Submission ID: 213522

Submission date: 11/13/2024 11:36:57 AM

**RE: 74-76 BEACONSFIELD ROAD, MOSS VALE, NSW 2577
SSD-9409987
CONSTRUCTION AND OPERATION OF A PLASTICS RECYCLING
FACILITY WITH THE CAPACITY TO PROCESS UP TO 120,000 TONNES
OF PLASTIC WASTE PER ANNUM INTO USABLE PRODUCTS**

Figure 4: Extract from Wingecarribee 2040 Local Strategic Planning Statement, Infrastructure pg.55.

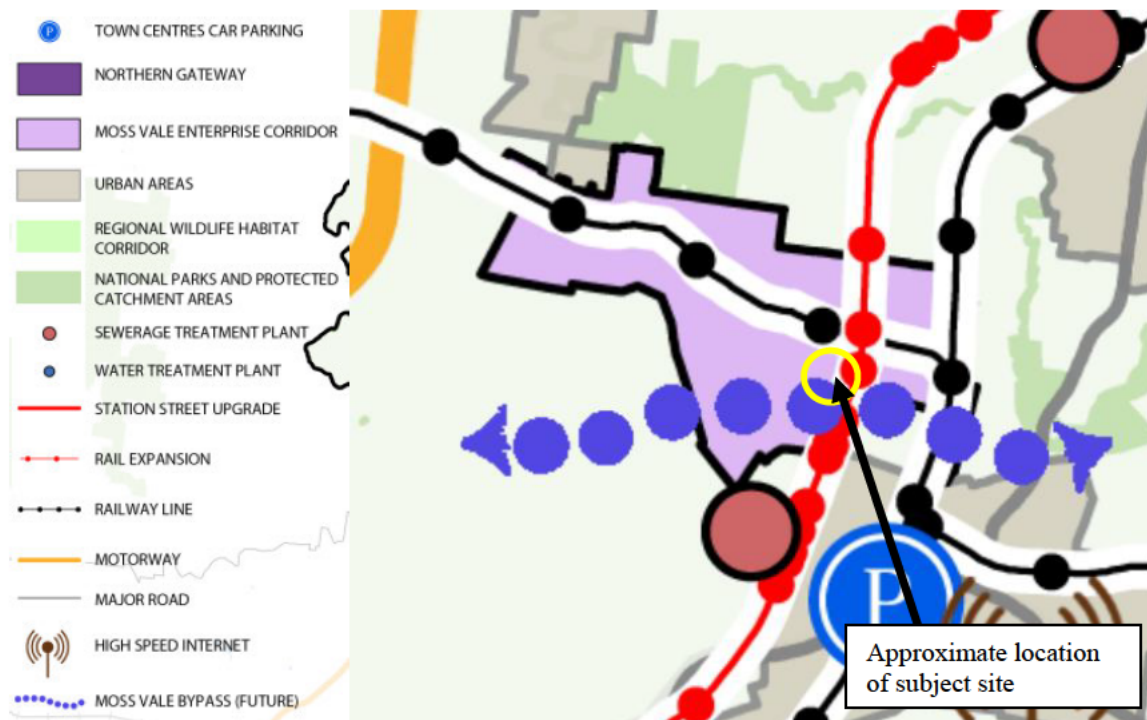
The Moss Vale Enterprise Corridor is referenced throughout the strategic planning statement with many of the strategic visions/plans for the corridor based around improving infrastructure and securing funding to enable the development of the corridor as a major industry and investment hub for the Wingecarribee LGA. Two of the infrastructure projects included the strategic planning statement is the future Moss Vale Bypass and rail expansion which appears to run in close proximity to the proposed plastic recycling site. Refer to Figure 4 below.

The submitted EIS has not addressed whether the proposed rail expansion or Moss Vale Bypass will impact the proposed development. Considering these infrastructure projects form part of Wingecarribee Council's strategic vision for the Moss Vale Enterprise Corridor, further analysis should be provided as to whether the proposed recycling facility will be impacted by these infrastructure projects.

Figure 5: Extract from Moss Vale Enterprise Corridor DCP 2008.

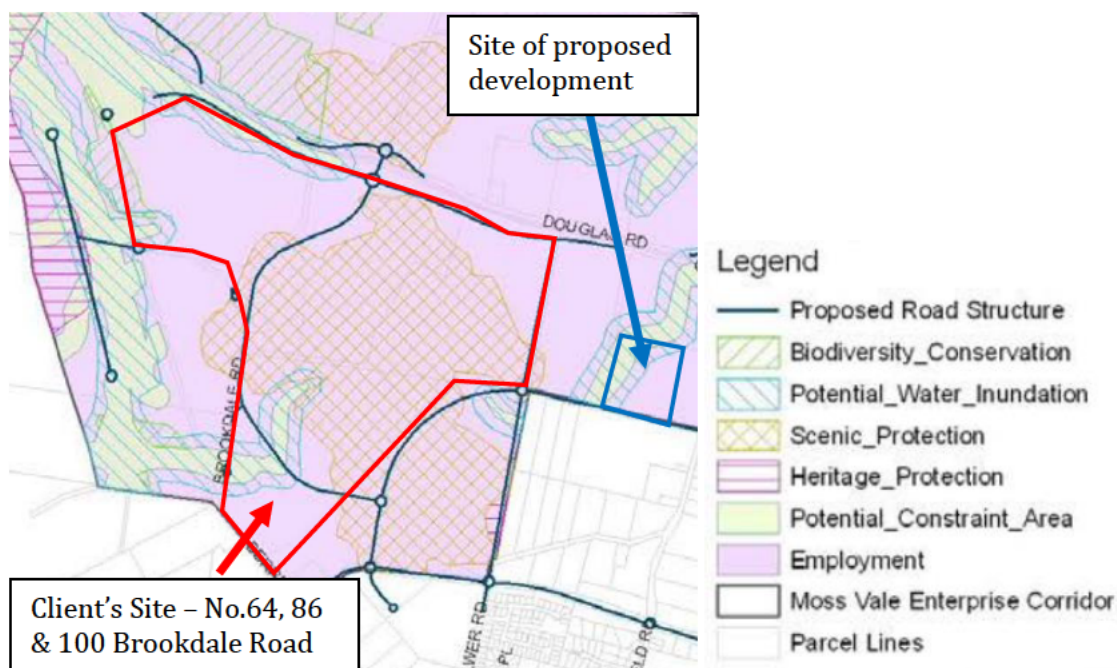
The view analysis undertaken has not consider views from my client's site. My client's site at No. 64, 86 & 100 Brookdale Road is at a higher point in relation to the immediate area, hence has scenic views of the surrounding rural landscape. The site is identified in the Moss Vale Enterprise Corridor DCP 2008 as being within a scenic protection area (see figure 5 below).

An updated view loss study should be undertaken which includes an assessment of the potential impact the proposed plastic recycling plant will have to views from my client's site, especially considering the site has been reserved for scenic protection.

Figure 2: Extract from Wingecarribee 2040 Local Strategic Planning Statement, Infrastructure pg.55.

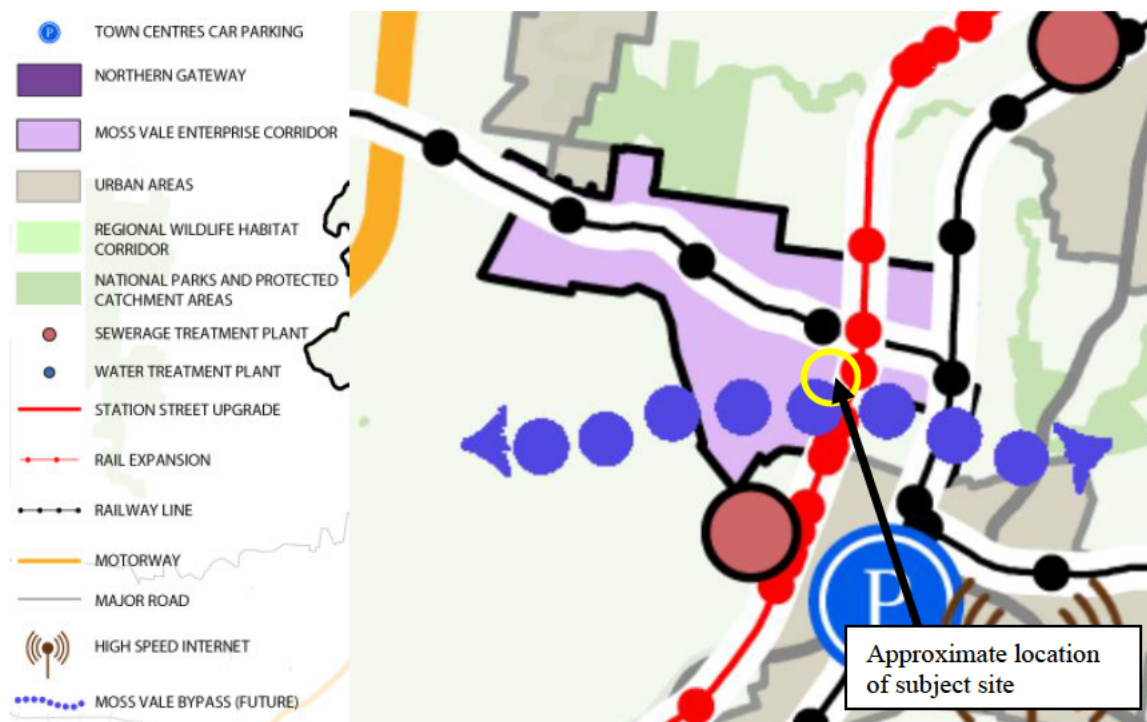
The Moss Vale Enterprise Corridor now known as the Southern Highlands Innovation Park (SHIP) is referenced throughout the strategic planning statement with many of the strategic visions/plans for the corridor based around improving infrastructure and securing funding to enable the development of the corridor as a major industry and investment hub for the Wingecarribee LGA. Two of the infrastructure projects included the strategic planning statement is the future Moss Vale Bypass and rail expansion which appears to run in close proximity to the proposed plastic recycling site. Refer to Figure 2 below.

The amended documentation has not addressed whether the proposed rail expansion or Moss Vale Bypass will impact the proposed development. Considering these infrastructure projects form part of Wingecarribee Council's strategic vision for the Southern Highlands Innovation Park, further analysis should be provided as to whether the proposed recycling facility will be impacted by these infrastructure projects.

Figure 3: Extract from Moss Vale Enterprise Corridor DCP 2008.

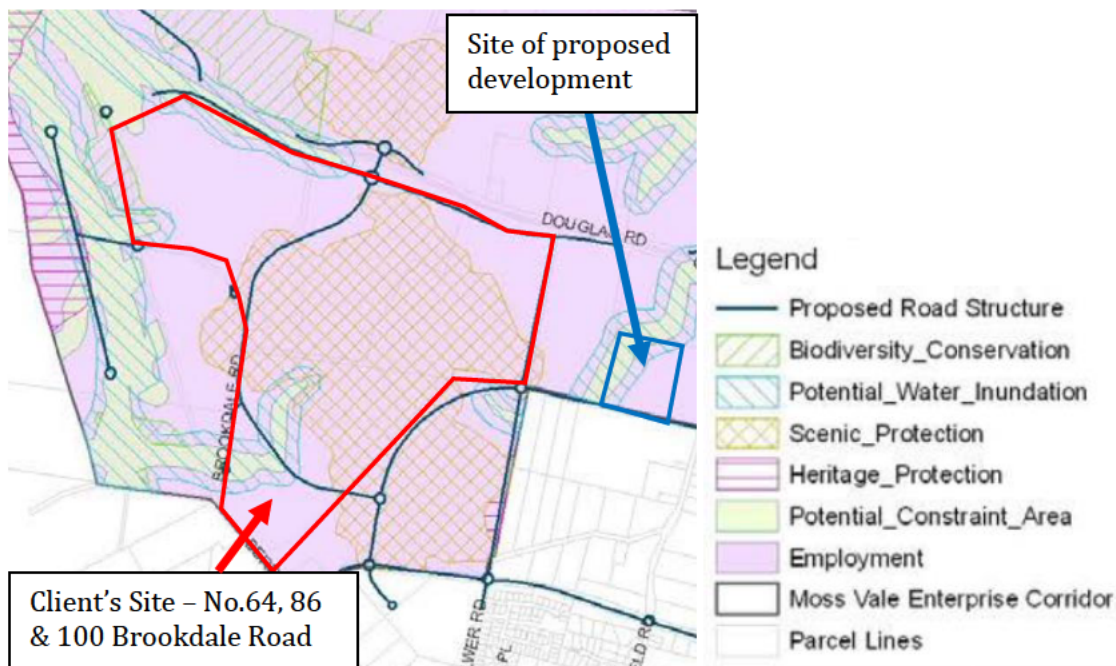
The amended documentation states that the maximum building height has been reduced from 18 metres to 15.5 metres to minimise visual impacts. However, despite being requested within the previous objection letter prepared, no view analysis has been taken from my client's site. The original and unamended view analysis did not consider views from No. 64, 86 & 100 Brookdale Road which is situated at a higher point in relation to the immediate area, hence has scenic views of the surrounding rural landscape. This is further evidenced by the fact that the site is identified in the Moss Vale Enterprise Corridor DCP 2008 as being within a scenic protection area (see Figure 3 below).

As previously requested, an updated view loss study should be undertaken which includes an assessment of the potential impact the proposed plastic recycling plant will have to views from my client's site, especially considering the site has been reserved for scenic protection.

Although a reduced building height represents an improvement to the original scheme, in the absence of an updated visual impact study we are unable to confirm the impact the proposed factory will have on views from my client's property. Furthermore, although requested in the original objection letter, no details of the proposed landscape screening have been shown on the updated set of architectural plans. The original EIS prepared for the development outlined that landscape screening would be incorporated to offset the visual intrusion generated by the proposed plastic recycling factory. These details should be provided to demonstrate whether the proposed landscaping will adequately screen the visual intrusion of the plastic recycling factory and be exhibited for further comment.

Figure 4: Extract of Draft SHIP Structure Plan taken from Agenda of the Ordinary Meeting of Council - Wednesday 15 February 2023.

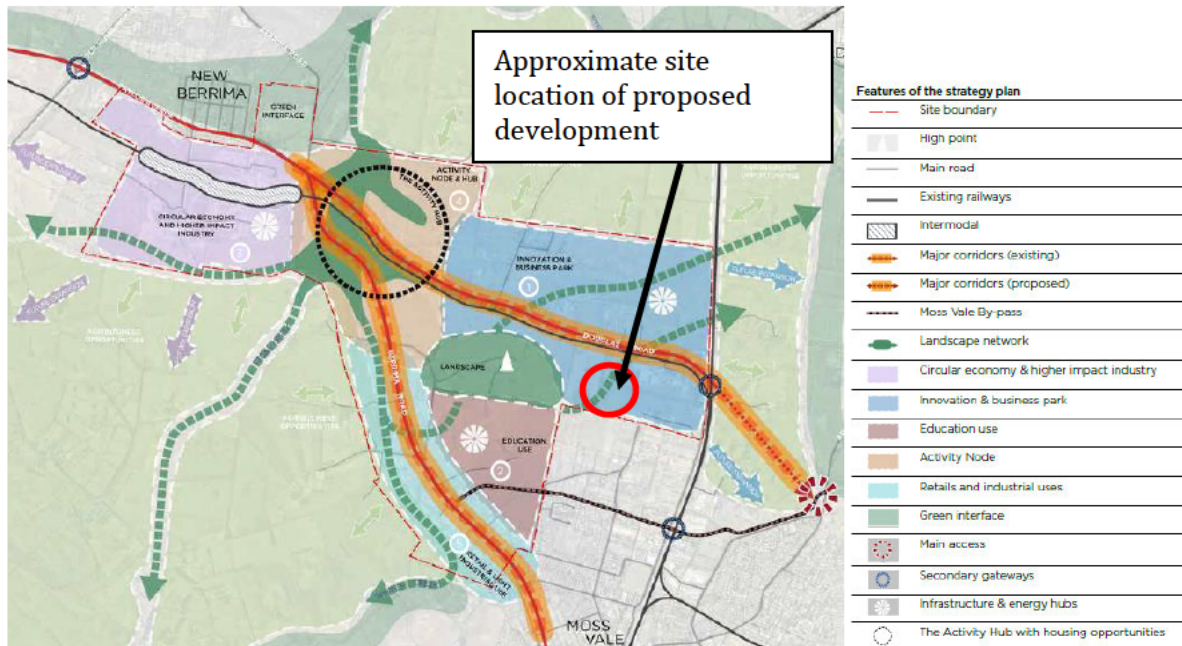
The landscape network identified in the draft structure plan above appears to follow the existing waterway which flows towards the Wingecarribee River. The draft structure plan indicates that the site sits within a landscape network. The proposed location of the plastic recycling factory appears to be in conflict with the draft structure plan envisaged by Wingecarribee Shire Council for the SHIP.

Moreover, the structure plan indicates that a new major road corridor will connect the Hume Highway with Argyle Street via Douglas Road. As previously noted, the amended proposal seeks to utilise a north-south access road from Douglas Road and relocate the level crossing for the Berrima Branch Line. Further details should be provided to confirm whether the proposed changes to the road and rail network will remain consistent with the transport and infrastructure vision for the SHIP envisaged by Wingecarribee Shire Council.
